ADDENDUM ONE
HIGHLAND PARK (ANDERSON AVENUE) GI DEMONSTRATION PROJECT
CONTRACT NO. S-11-001-201
CITY OF CHATTANOOGA, TENNESSEE

The following changes shall be made to the Contract Documents, Specifications, and Drawings:

III. Updates to Drawings

REV	DATE	REVISION DESCRIPTION
REV1	10/24/2014	CONSENT DECREE SUBMITTAL
REV2	12/01/2016	BID SET
REV3	1/5/2017	ADDENDUM 1
REV4		
REV5		
REV6		
REV7		
REV8		
REV9		
REV10

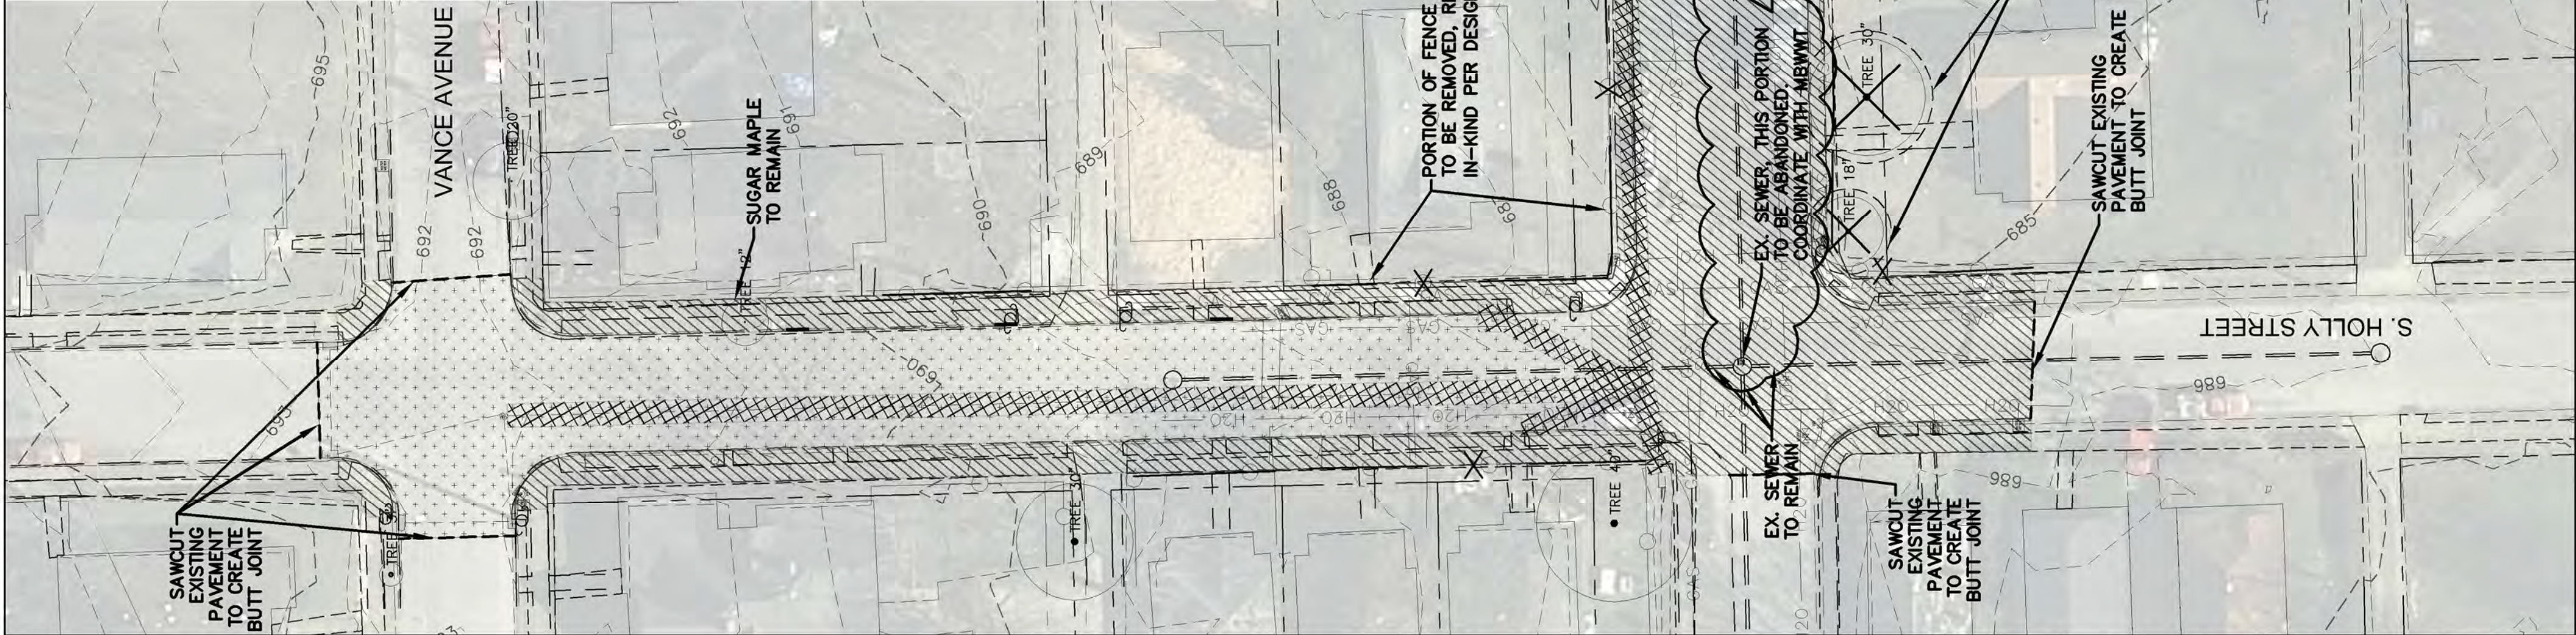
Shts 00L-101 and 102 Alt A revised, bid tab revised to reflect changes

TRAFFIC CONTROL AND DEMOLITION PLAN
SHEET: 00C-102

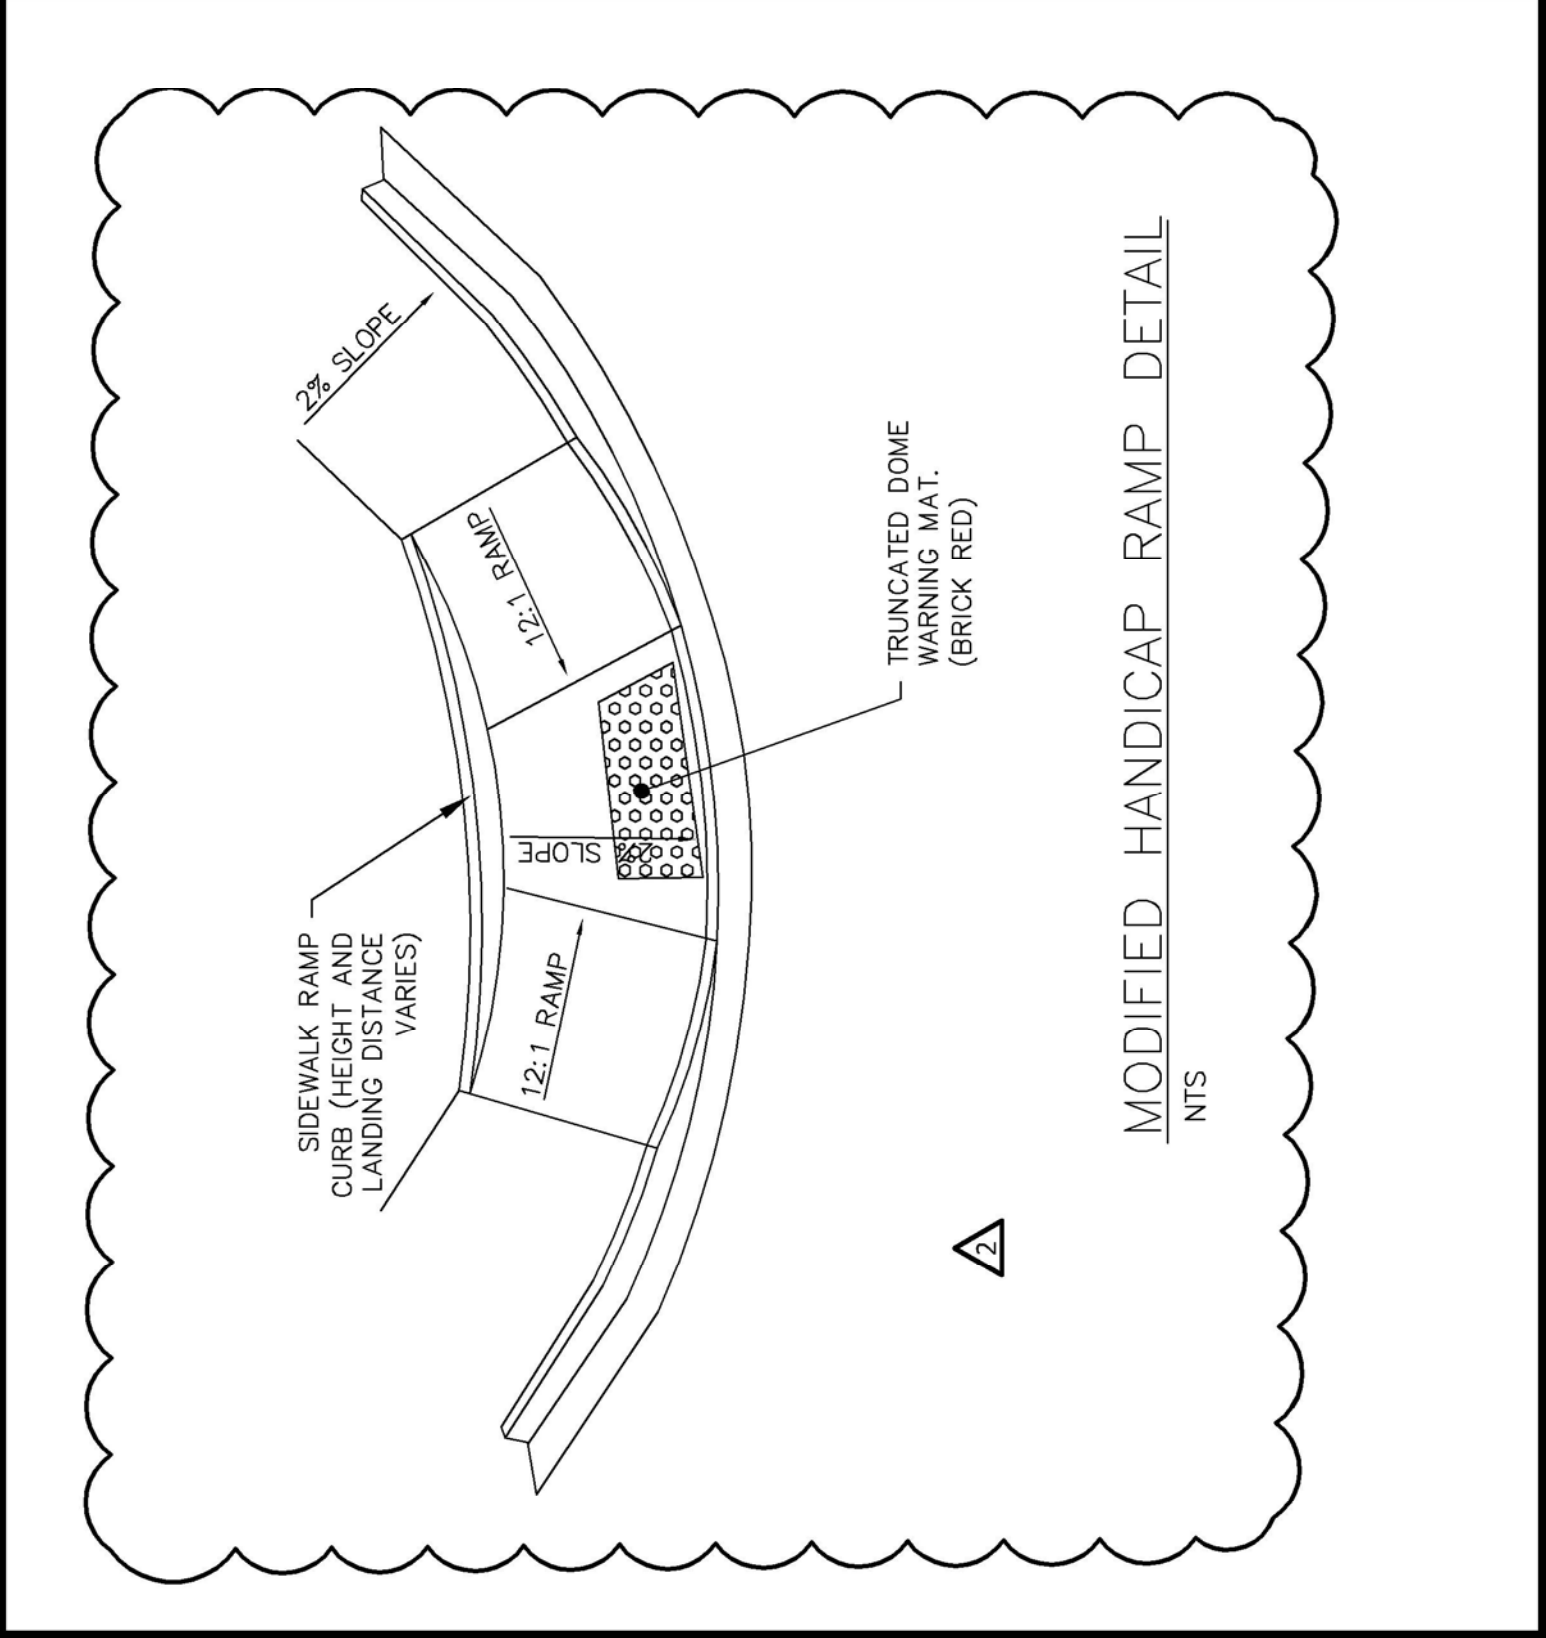
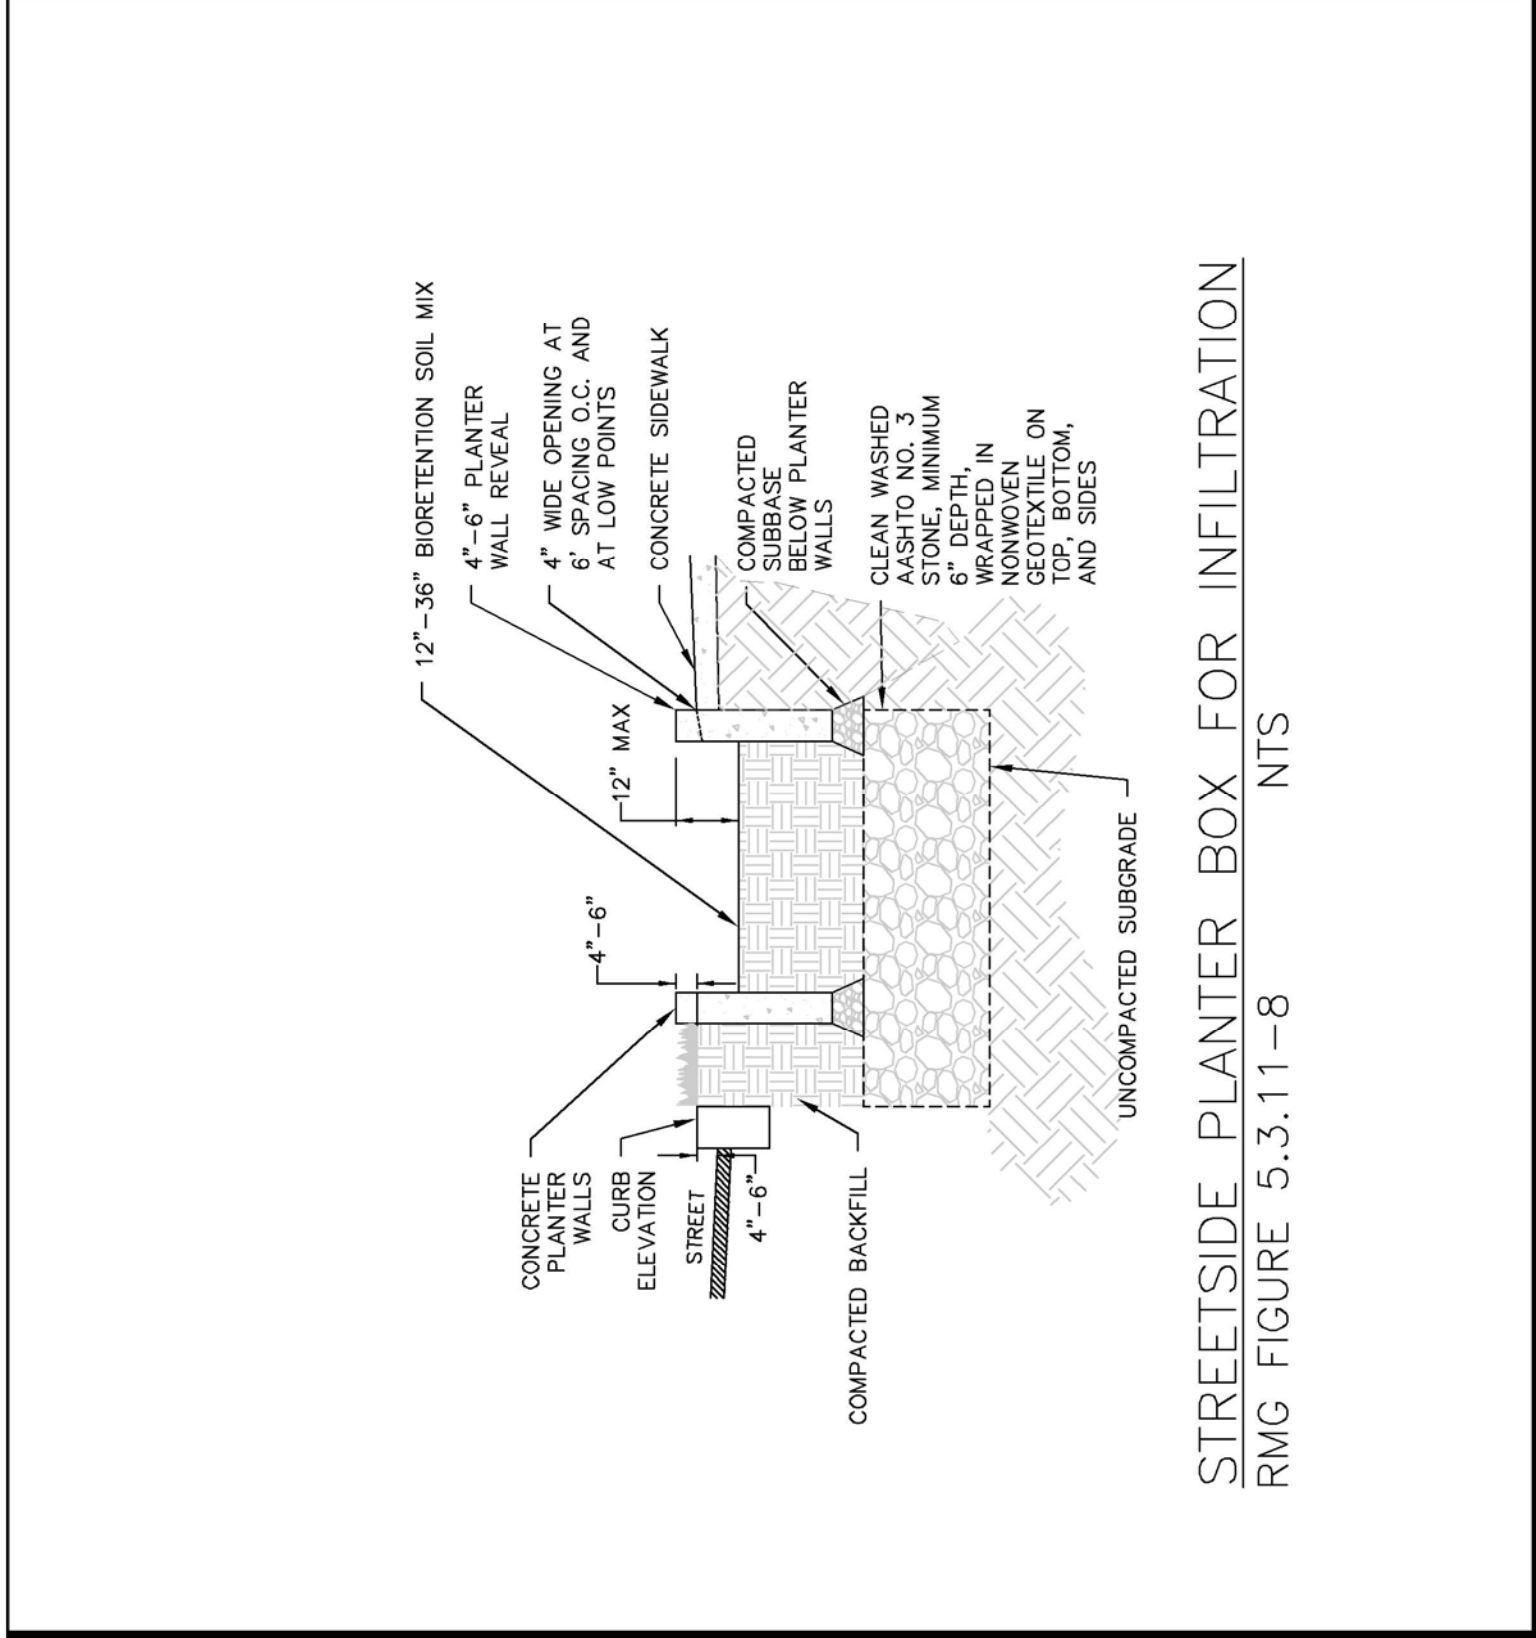
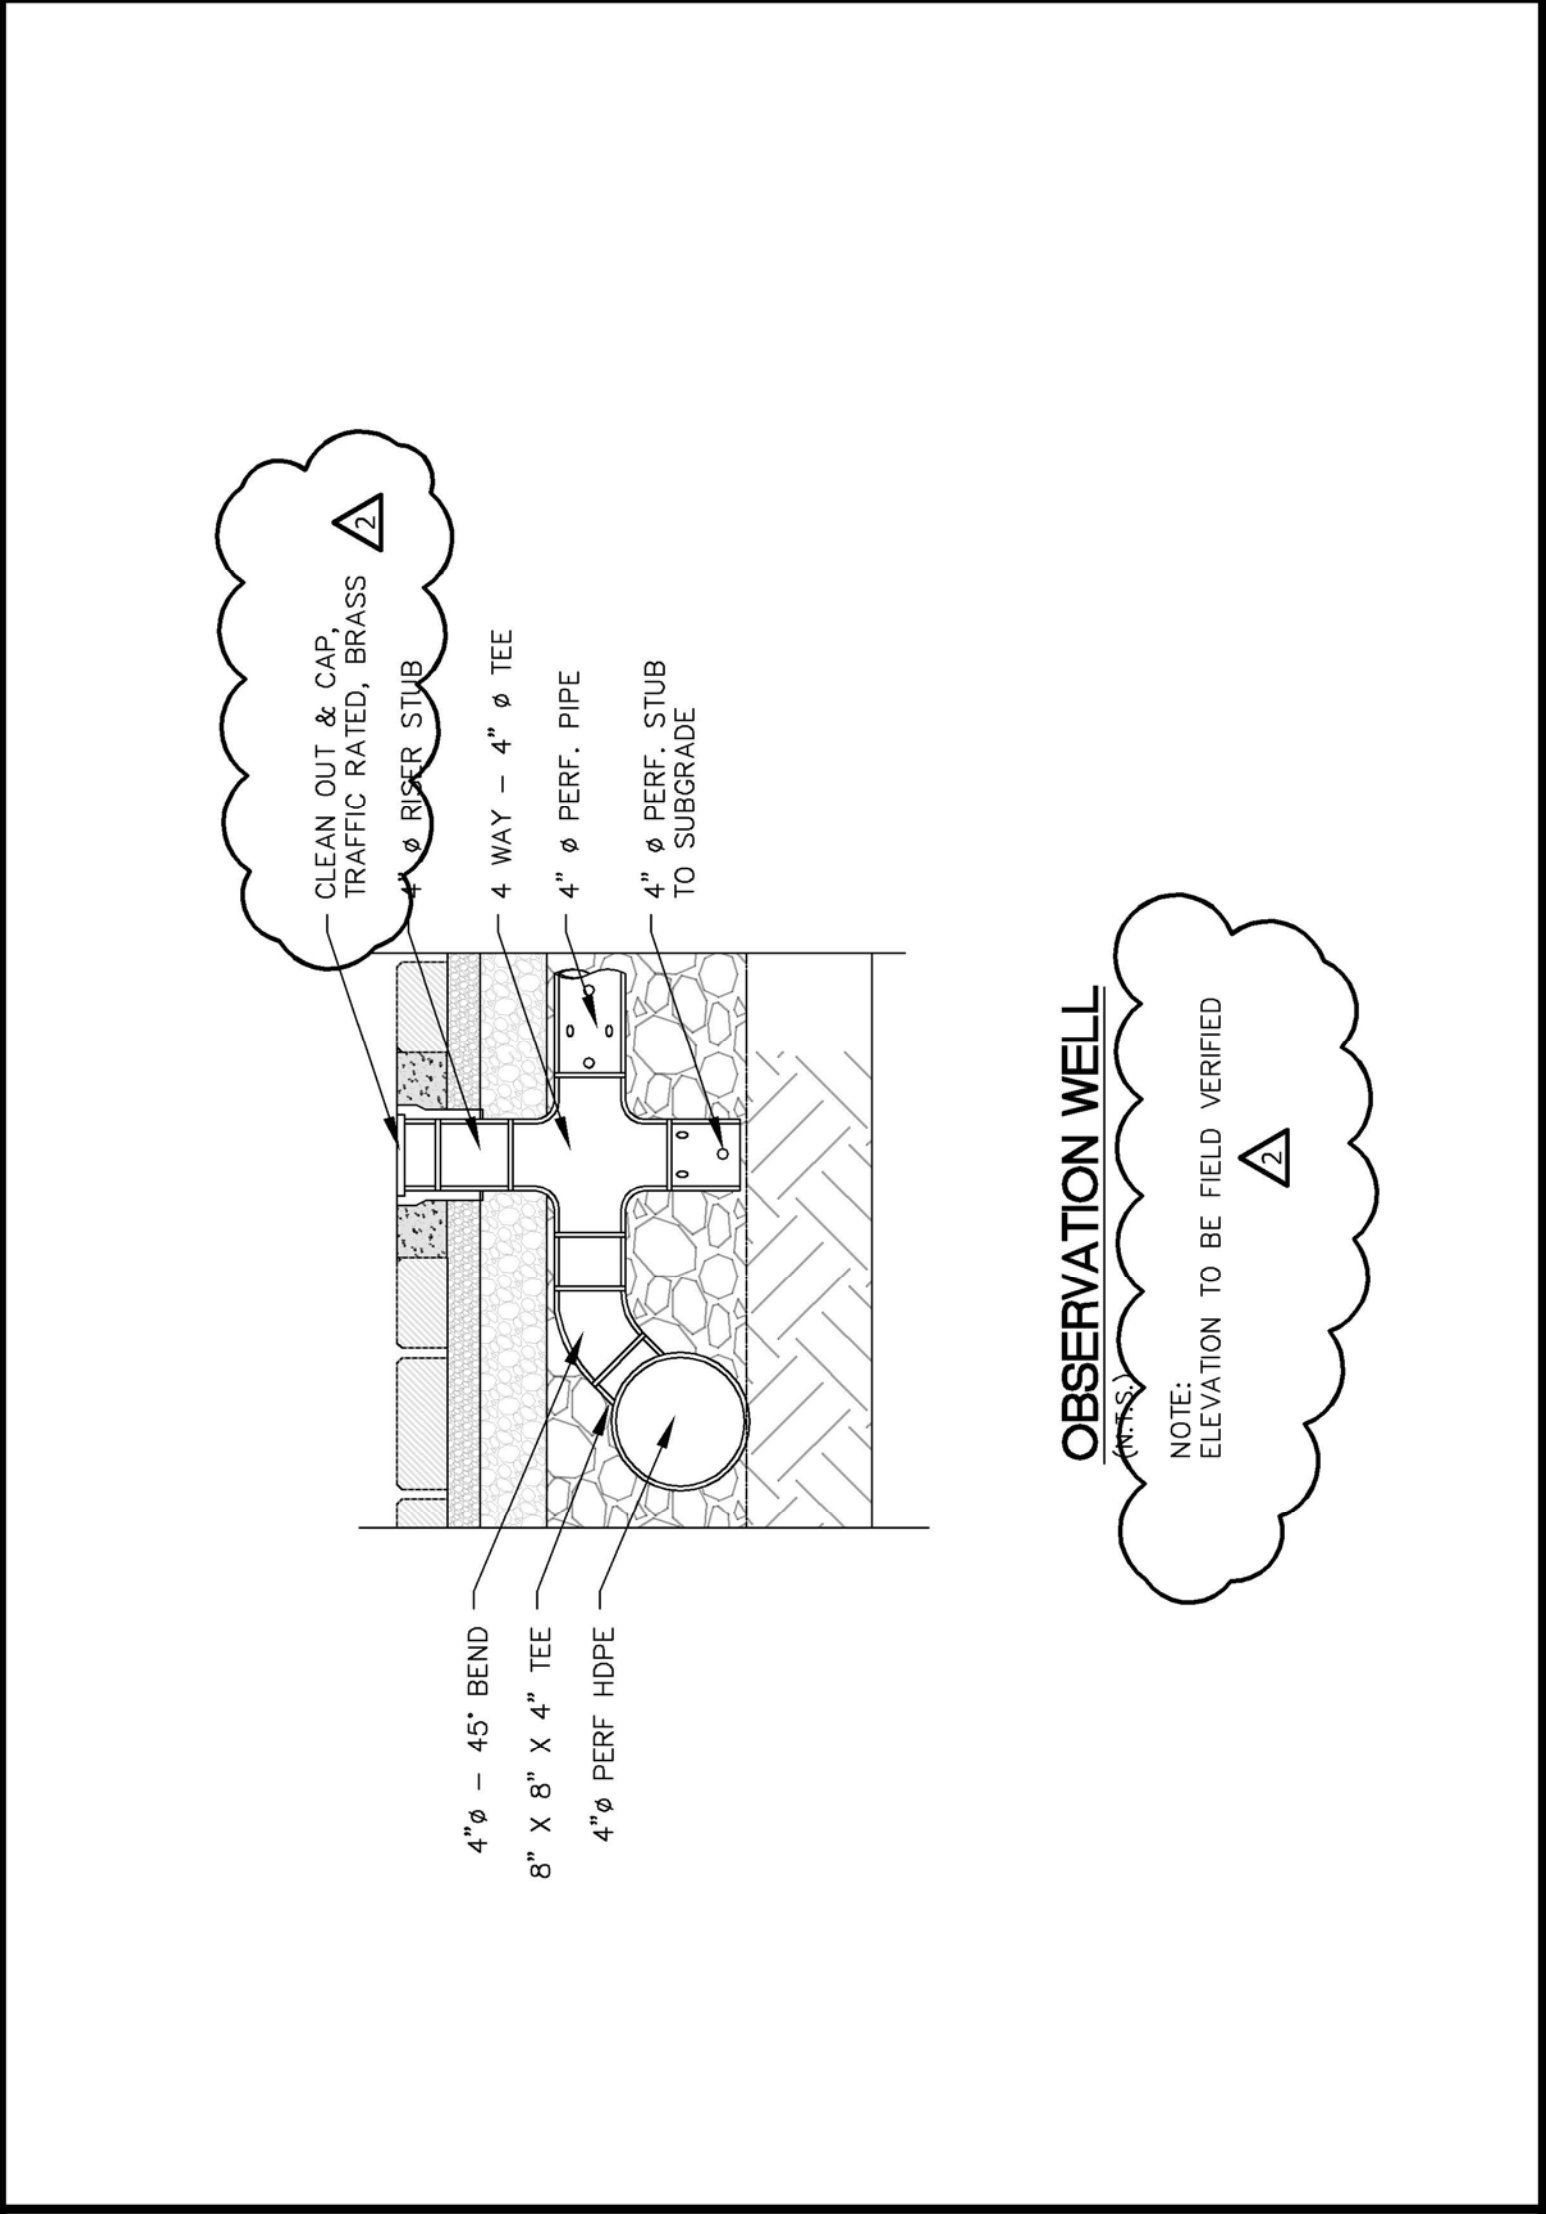
Sht 00C-102 Traffic Control Plan and demolition has been updated
